**Planning Application - 22/00585/FULL - The Whins, Old Whisky Road, Kirkton of Auchterhouse DD3 ORD (or The Brae, DD3 ORE)****Proposed erection of dwellinghouse and associated works****Comments and Objection by Auchterhouse Community Council**

**Planning Application 22/00585/FULL- Land South of the Whins, The Brae, Kirkton of Auchterhouse, DD3 0RE**

**Further Comments by Auchterhouse Community Council**

Overmarked driveway access plan showing inaccuracies on application drawings and obstructions to proposed sightlines.

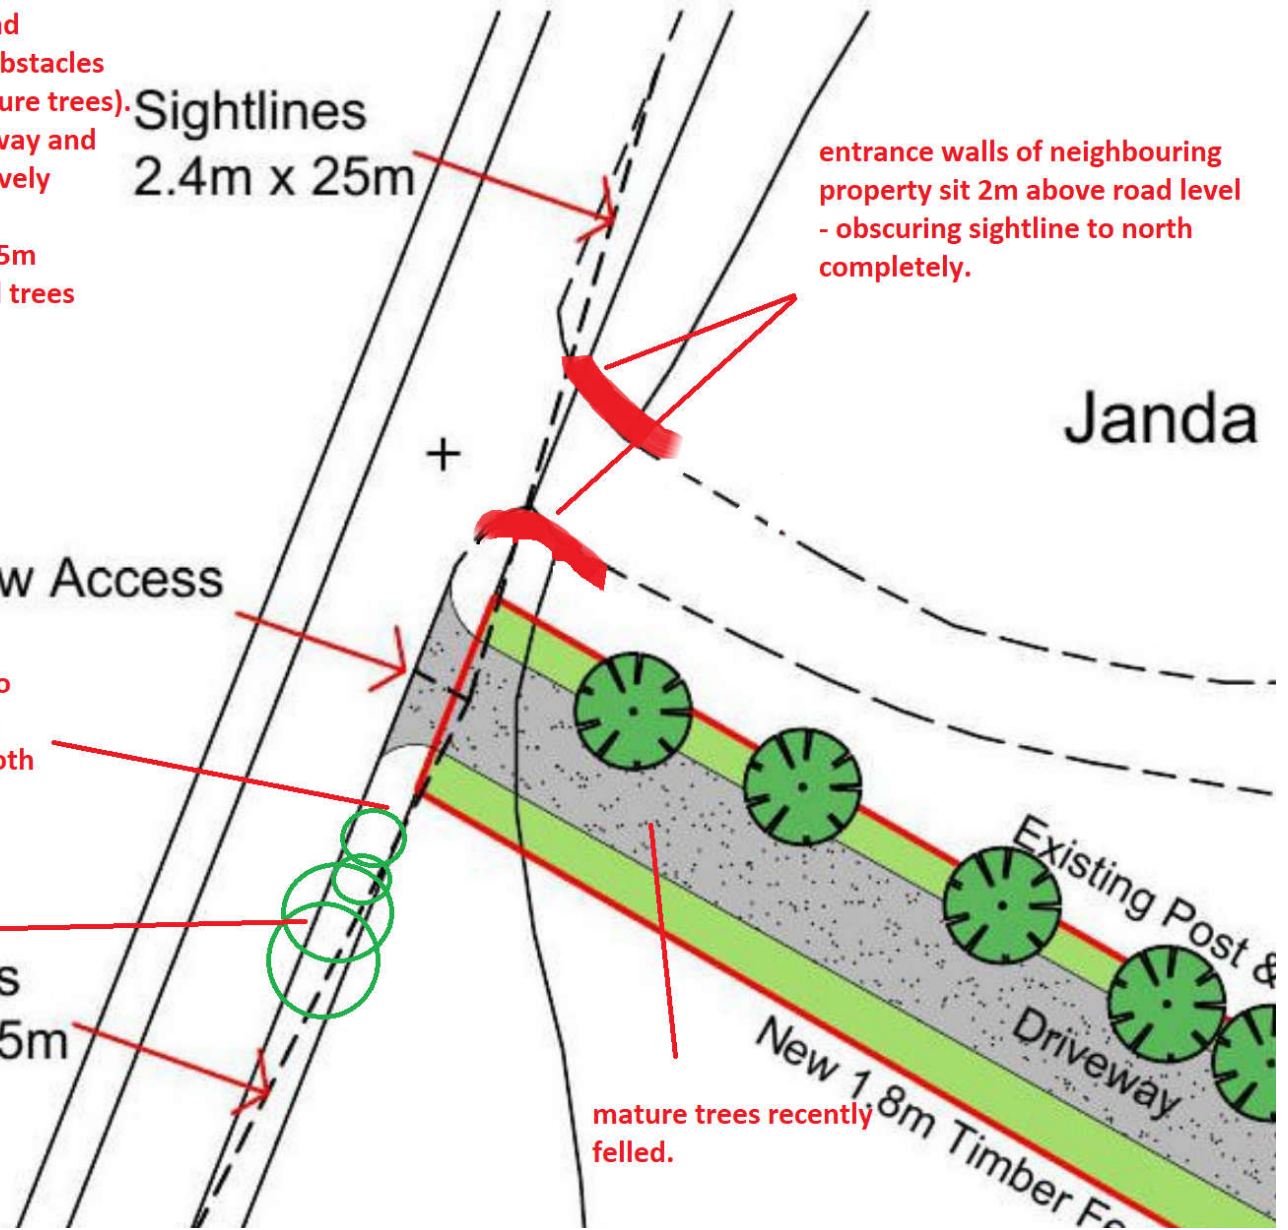
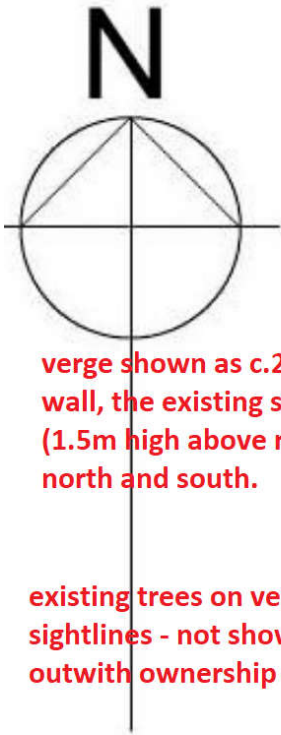
Sightlines shown on application drawing are inaccurate and misleading - they do not show the existence or height of obstacles outwith the control of the applicant (stone dykes and mature trees). The plan dont show the burn crossing the proposed driveway and illustrates the verge as being wider than it is (which massively distorts the sightlines). This road access cannot be formed with required 2.4m x 25m sightlines without removing neighbour's walls, shrubs and trees

entrance walls of neighbouring property sit 2m above road level - obscuring sightline to north completely.

verge shown as c.2m when it measures 1.3m from road to wall, the existing stone dyke outwith the application site (1.5m high above road level) obscures the sightlines to both north and south.

existing trees on verge obstruct sightlines - not shown on plans and outwith ownership of applicant

mature trees recently felled.

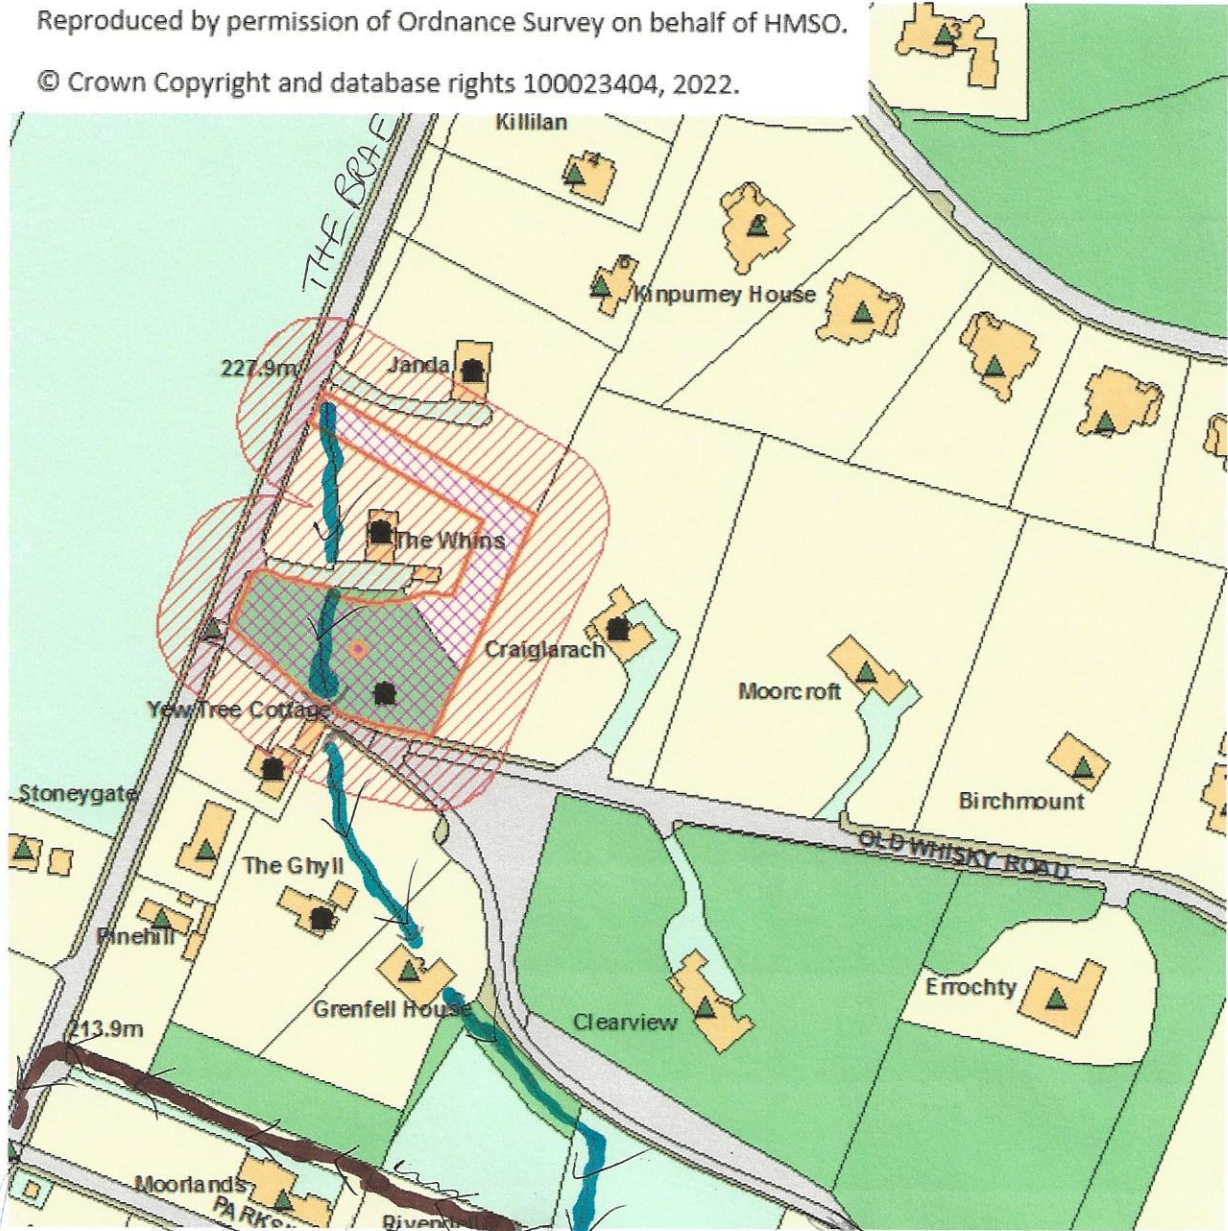
Secondly that the burn, which is shown on the planning application maps as terminating at Grenfell House does not terminate there but is routed in a culvert under Grenfell House. It emerges on the other side, continues along the upper edge of the field to the north of Parkside, takes a right-angled turn down the field and under the stone wall into a pond in the garden of Palm springs in Parkside. From there it is channelled into a sump in the north corner of Rivendell in Parkside and then piped into a closed stone culvert on the north side of Moorlands on the corner of Parkside and The Brae before being piped down The Brae to Kirkton of Auchterhouse village. I have amended a map already used in this application to show the actual route of the burn under Old Whisky Road and on down to Parkside and then along to the Brae through another culvert. Water flowing down the burn, therefore, can affect properties immediately to the south.
